DESIGN ADVISORY BOARD Tuesday, May 23, 2017 at 3:00 PM Conference Room 12, City Hall, Burlington, VT Agenda

TO: Design Advisory Board
FROM: Scott Gustin
DATE: May 23, 2017
RE: 17-1081PD, 451 Ethan Allen Parkway

Request: Final plat review for 9-unit planned unit development and associated site improvements

LANDSCAPING & GRADING PLAN

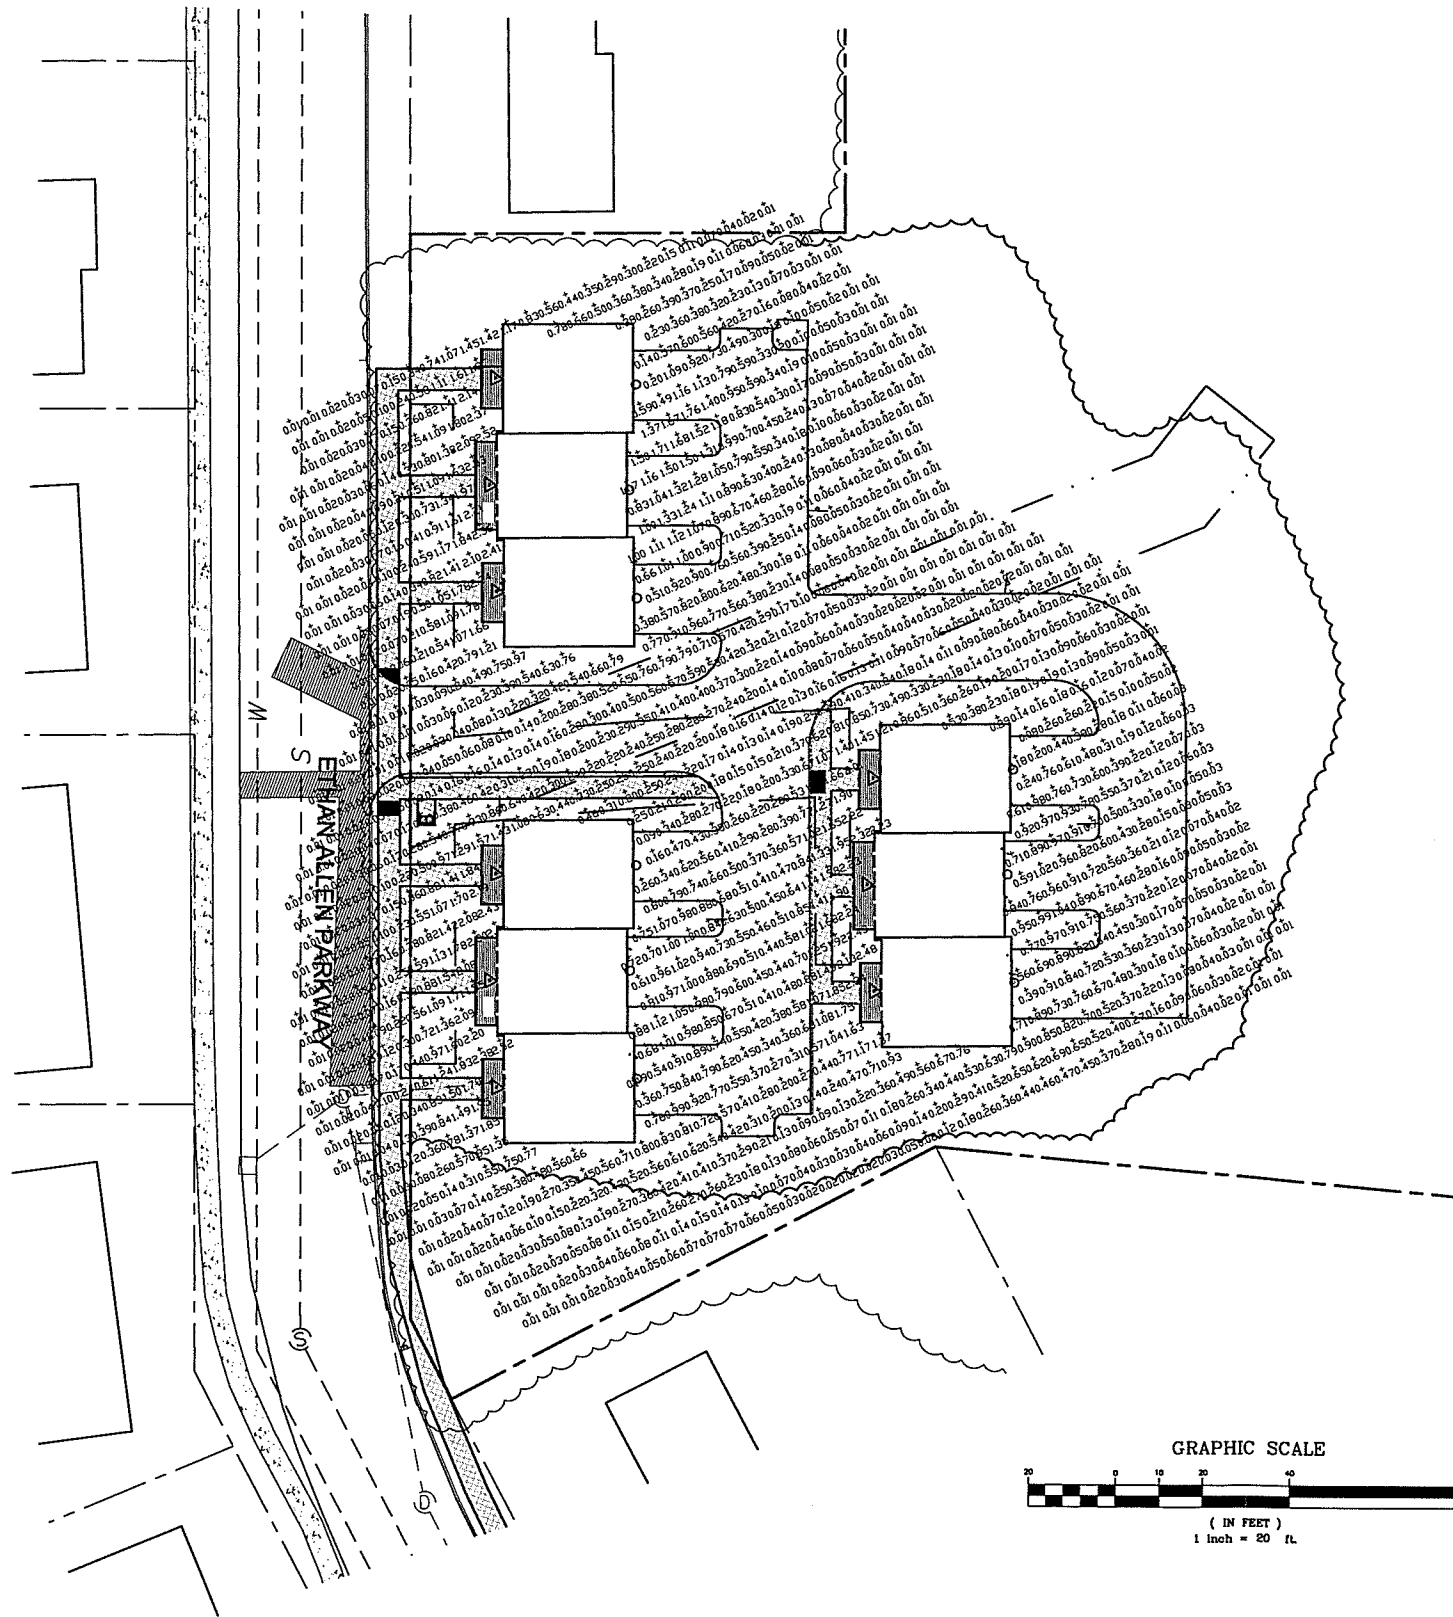
Sheets A4 and A5 of the attached ADS building plans have been revised to show the same vertical difference between the grade in the front yard and the driveways as shown on Lamoureux & Dickinson (L&D) Sheet #5.

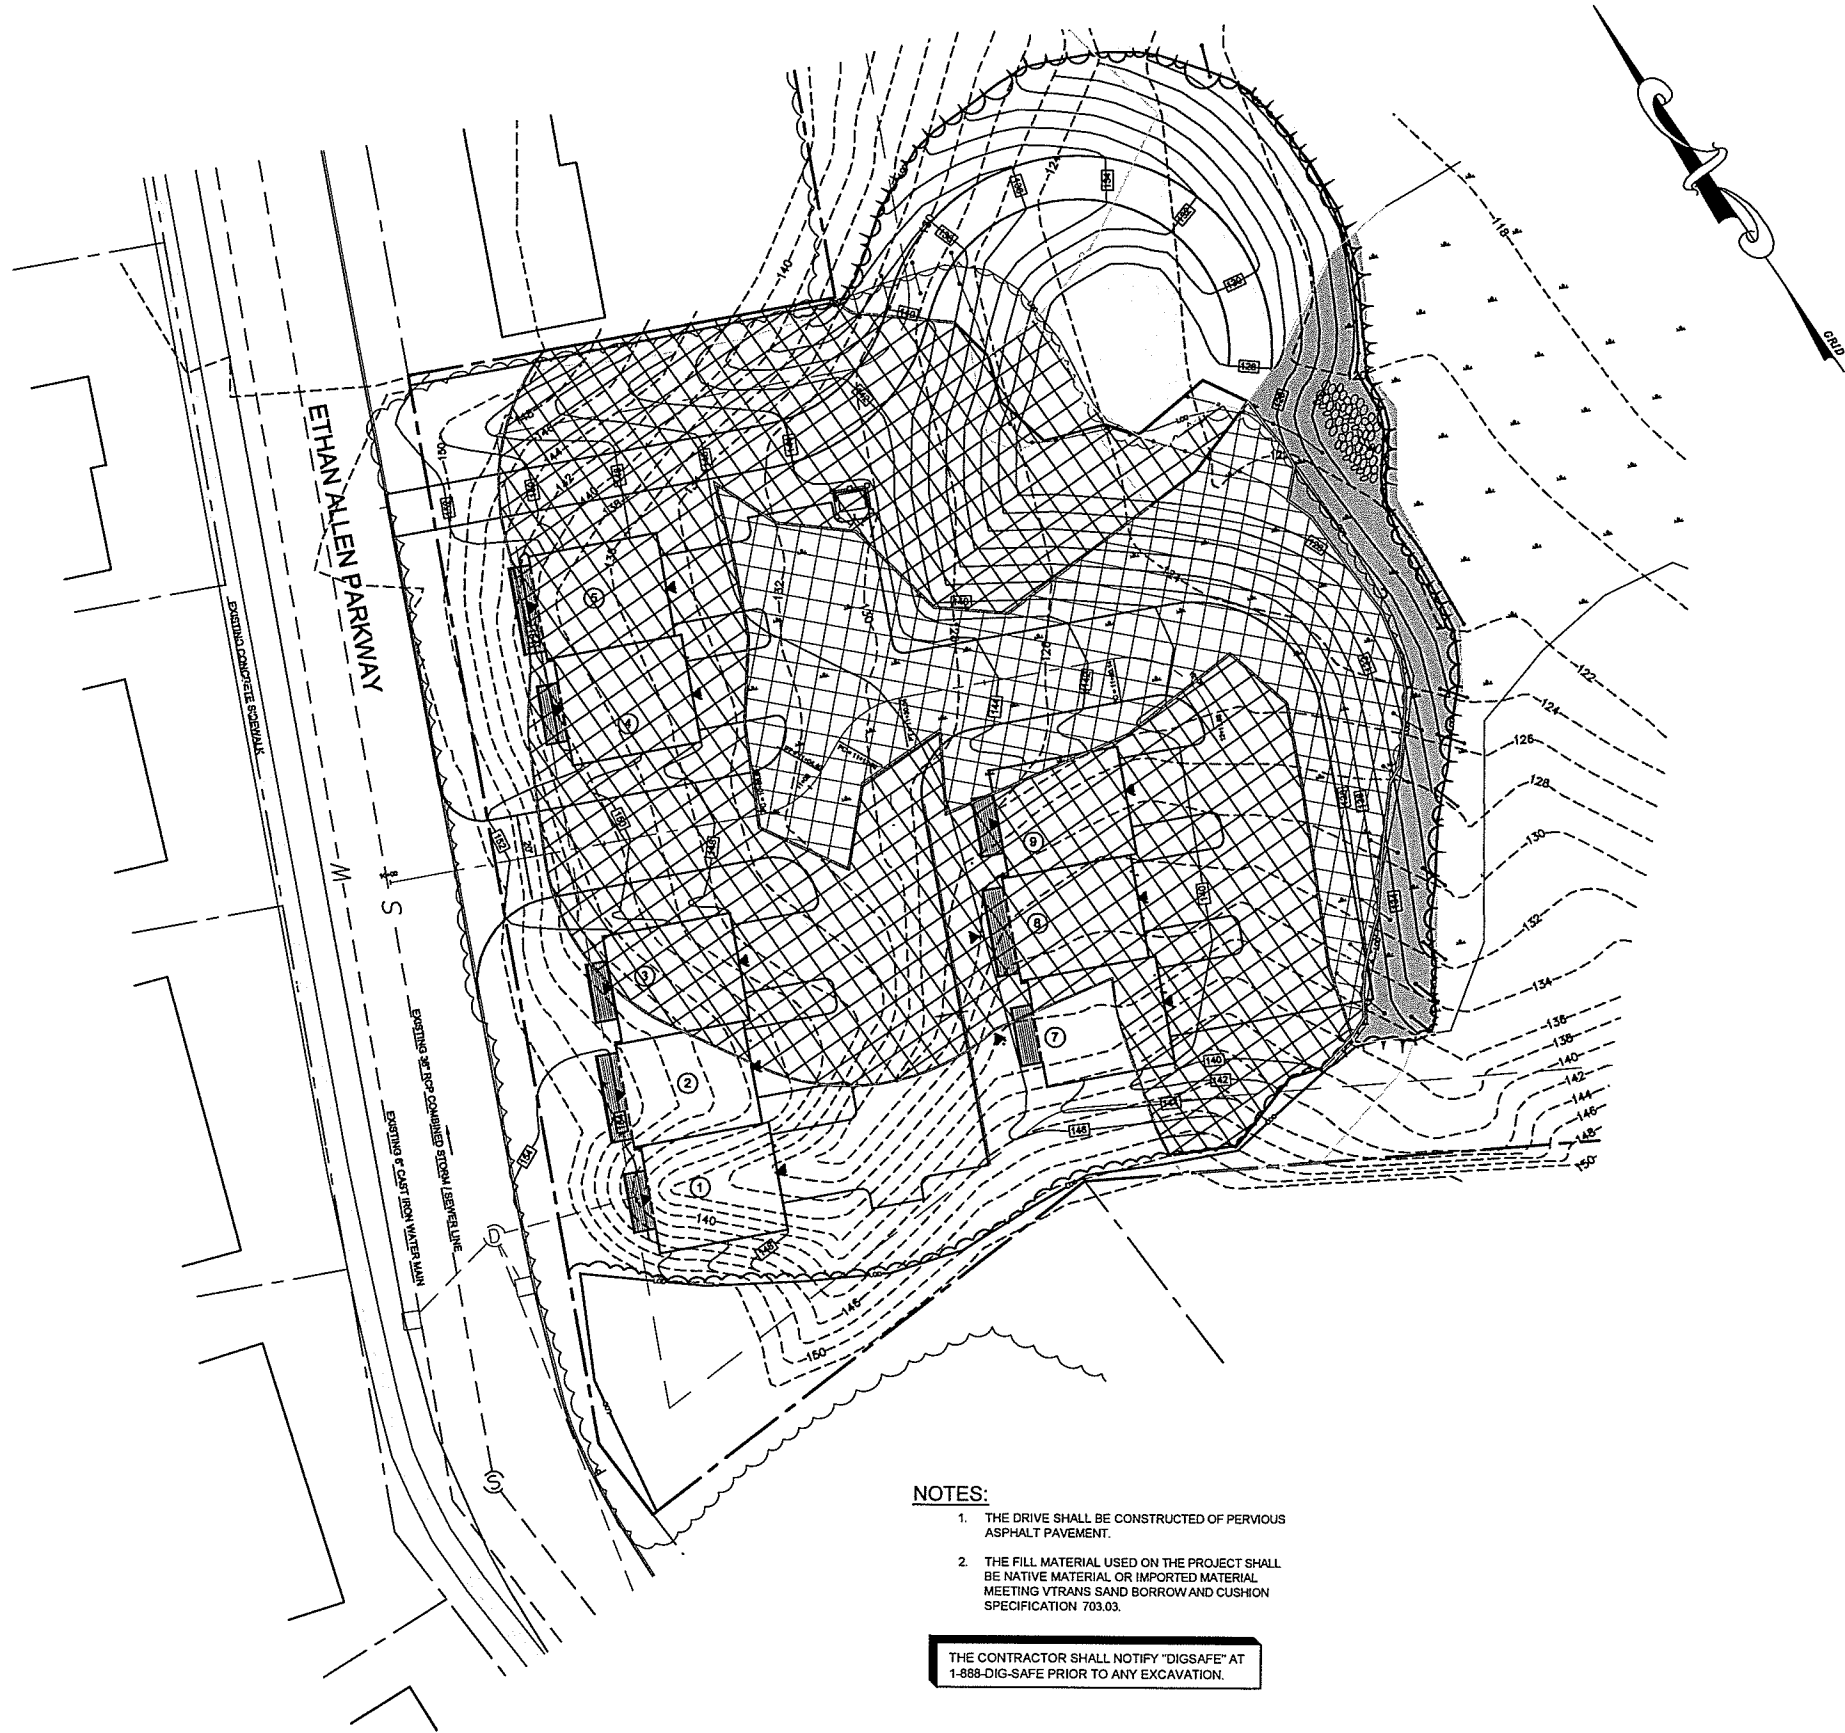
L&D Sheet 12A shows the approximately 4,000 sf of additional wetland buffer impact area and approximately 3,100 sf of additional wetland impacts required to satisfy the requests of the Fire Marshall and the Stormwater Director. The State Wetlands permit does not allow Tim and Bill to further disturb the wetlands and buffer and the Conservation Commission has previously requested that Tim and Bill minimize wetlands and buffer disturbance. As shown on L&D Sheet 4, in lieu of a long road down to a new manhole at the bottom of the bank, we propose to place the new storm manhole within the paved private drive as an inside drop manhole, allowing the outlet pipe to the level spreader to be constructed at a slope of 1%.
